**METROPOLITAN GOVERNMENT OF NASHVILLE AND DAVIDSON COUNTY**

**STAFF RECOMMENDATION**  
**1919 19<sup>th</sup> Avenue South**  
**September 21, 2016**

**Application:** New construction—detached accessory dwelling unit; Setback determination

<p><b>Description of Project:</b> Application is to construct a detached accessory dwelling unit (DADU) at the rear of the lot. The structure requires a setback determination to be located ten feet (10') from the rear of the property and three feet (3') from the right side.</p> <p><b>Recommendation Summary:</b> Staff recommends approval of the detached accessory dwelling unit with the following conditions:</p> <ol style="list-style-type: none"><li>1. The right side setback shall be a minimum of five feet (5');</li><li>2. Staff shall approve the window and door selections prior to installation; and</li><li>3. A restrictive covenant for the detached accessory dwelling unit shall be filed with the Register of Deeds prior to issuance of a permit.</li></ol> <p>With these conditions, staff finds that the detached accessory dwelling unit meets Ordinance 17.16.030. G. and Section II.B.i of the design guidelines for the Belmont-Hillsboro Neighborhood

SITE PLAN FOR HISTORIC

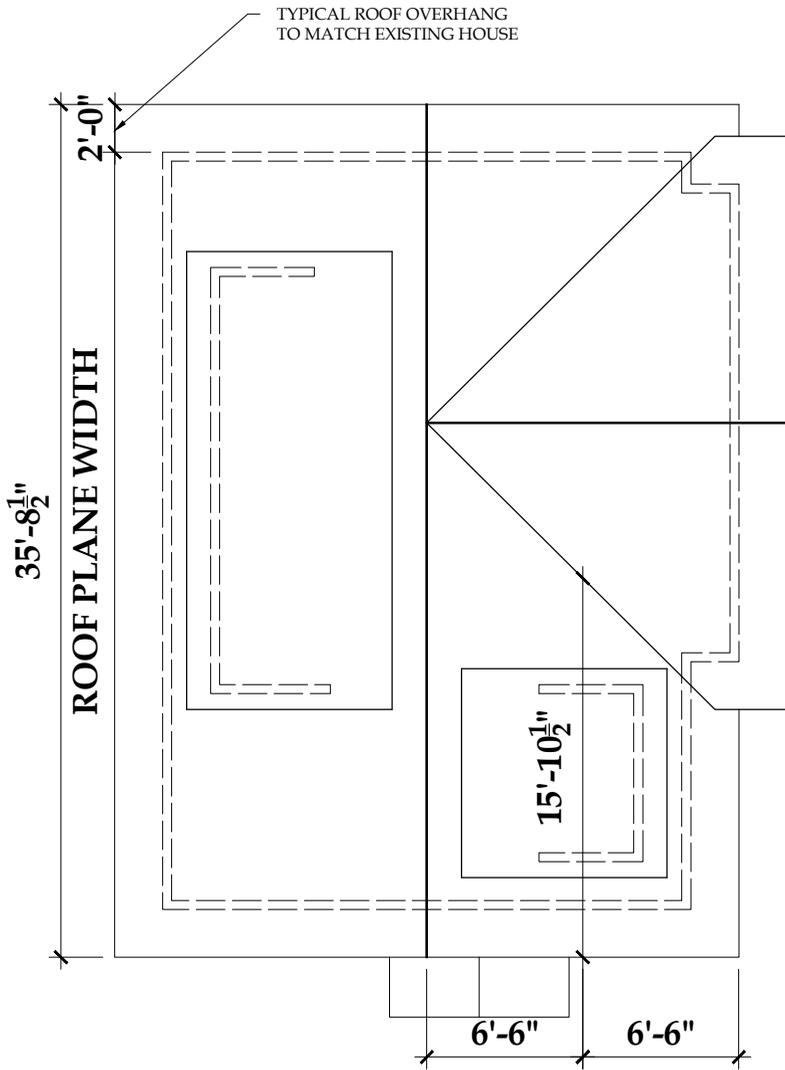
The base zoning for this building requires a twenty foot (20') rear setback and five foot (5') side setbacks. The applicant is requesting that the building have a ten foot (10') rear setback and a three foot (3') right side setback. The Commission has the ability to set setbacks that are appropriate for the lot and the district; however, the Commission has never deviated from the DADU ordinance's side setback requirement. Rear setback determinations have been routinely approved for DADUs because outbuildings were historically built closer to the rear, and because doing so does not directly affect neighboring properties due to alley buffer. The Commission has not approved side setbacks less than the minimums given by Metro Code for a DADU because the use of the building will be used differently than a standard garage. The Commission has found that the five-foot setback is appropriate for DADUs in all instances where it is required to meet the bulk zoning.

With the condition that the building meets the standard five foot (5') side setback requirement, Staff finds the project will meet section II.B.h.1 of the design guidelines and 17.16.30.G-4 of the applicable ordinance.

1. The right side setback shall be a minimum of five feet (5’);
2. Staff shall approve the window and door selections prior to installation; and
3. A restrictive covenant for the detached accessory dwelling unit shall be filed with the Register of Deeds prior to issuance of a permit.
